Additional Information Civil Engineering Response – Transportation Planning

Residential Development at Clonburris, Adamstown, Co. Dublin

October 2023

Client Name: Clear Real Estate Holdings Limited
Document Reference: 21-055r.011 Additional Information Response
Project Number: 21-055

Figure 1 | Road Safety Auditor – Additional Information Layout Statement

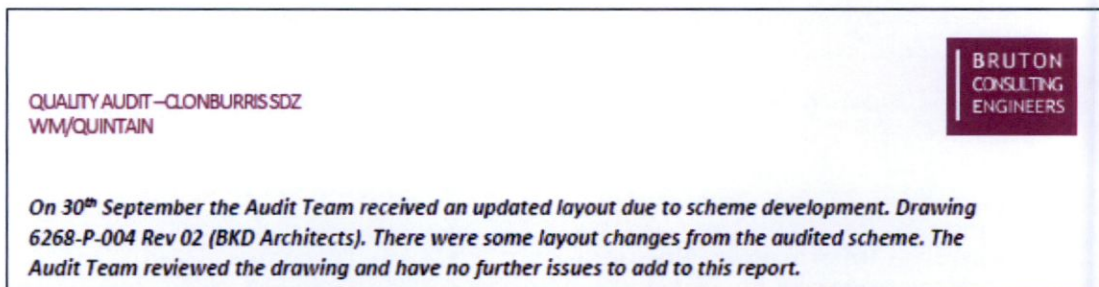
For the purposes of due diligence, the altered Additional Information layout has been supplied to the Road Safety Auditor for comment, who has confirmed that the layout changes have not brought about any further issues to add to the Quality Audit. The revised QA report including commentary to this effect snip are appended as Appendix B of this report and the snip extract statement is supplied below as *Figure 1*.

3.1 Problem

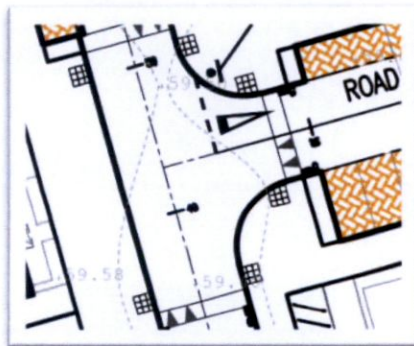
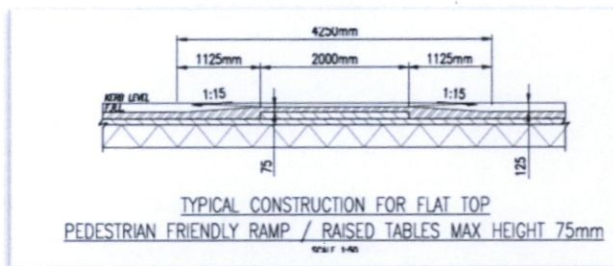
Drawing 21-055 P1010 & P1120 Rev – Nov 2022, Internal junctions.

It is proposed to provide raised tables at many internal junctions. If there is too small of a kerb upstand drivers may cut the corners given the tight radii and mount the footpaths. This could lead to breaking of the tactile paving which would become a trip hazard for pedestrians.

It is recommended that suitable kerb upstands be provided at the raised table areas that will make it unattractive for drivers to mount the kerb. The kerbs will need to be flush at the crossing points.

Recommendation accepted. Raised ramps are to be 75mm high, leaving a 50mm kerb upstand. The kerb is only to be flush 0-6mm at crossing point and raised in between to 50mm height to prevent kerb overrun.

3.1	Yes	Yes	Raised ramp to be 75mm high, leaving 50mm kerb upstand. The kerb is only to be flush 0-6mm at crossing point and raised in between to 50mm height to prevent kerb overrun.

3.4 Problem

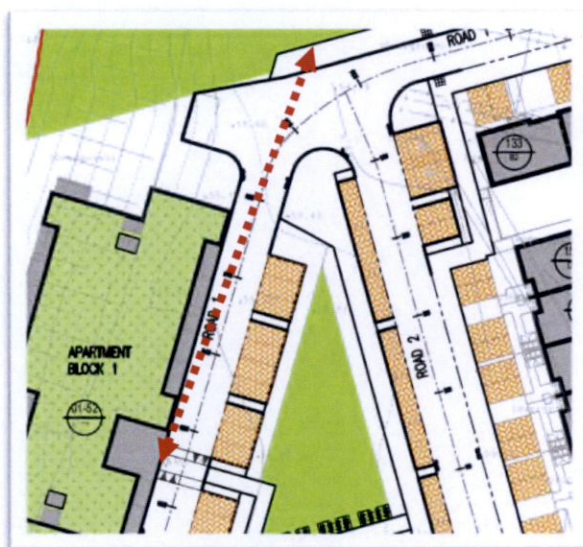
Drawing 21-055 P1010 Rev – Nov 2022, Apartment Block 1.

There is a missing link of footpath between Apartment Block 1 and the section of Road 1 to the east of the junction with Road 2. This could lead to pedestrians travelling on the carriageway which has not been designed as a shared use surface. Visitors parking in front of Apartment Block 1 would also have to travel along the carriageway to the access point to the building.

It is recommended that the grassed verge to the rear of the perpendicular parking spaces be changed to a footpath and that a suitable crossing of Road 1 be provided.

Recommendation accepted. We are now proposing a raised crossing at the northern end of the scheme, providing a safe VRU linkage point between the apartments and the path on the northern boundary. This is proposed to link with a new footpath that passes through the open space fronting the apartments, affording direct and safe access and desire line path linkages for residents and VRUs.

3.4	Yes	Yes	<p>We are proposing a raised crossing at the northern end of the scheme, providing a safe VRU linkage point between the apartments and the path on the northern boundary. This is proposed to link with a new footpath that passes through the open space fronting the apartments, affording direct and safe access and desire line path linkages for residents and VRUs.</p>

3.5 Problem

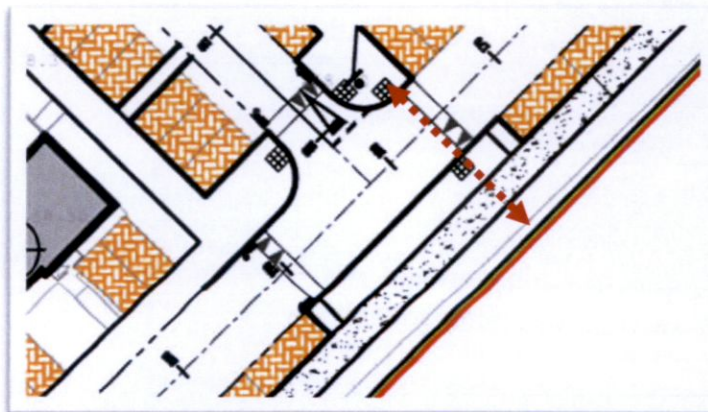
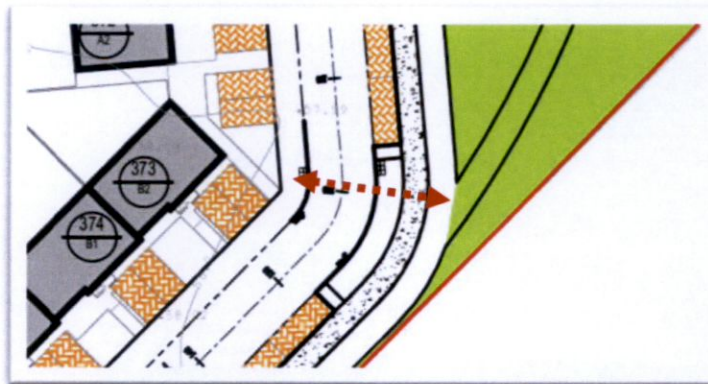
Drawing 21-055 P1010 Rev – Nov 2022, Road 4.

There is no proposed gap in the verge for pedestrians to access the residential units/internal roads at the junction of Road 9 and at the crossing point at house no. 373. This could lead to slips and falls in the grassed verge.

Provide suitable gaps in the verge at the pedestrian desire lines.

Recommendation accepted. Drawings have been updated to show the addition of gaps in the verges for pedestrian access in the requested locations.

Paragraph No. in Quality Audit Report	Problem accepted (yes/no)	Recommended measure accepted (yes/no)	Alternative measures (describe)	Alternative measures accepted by Auditors (Yes/No)
3.5	Yes	Yes	Drawings to be updated to show the addition of gaps in the verges for pedestrian access.
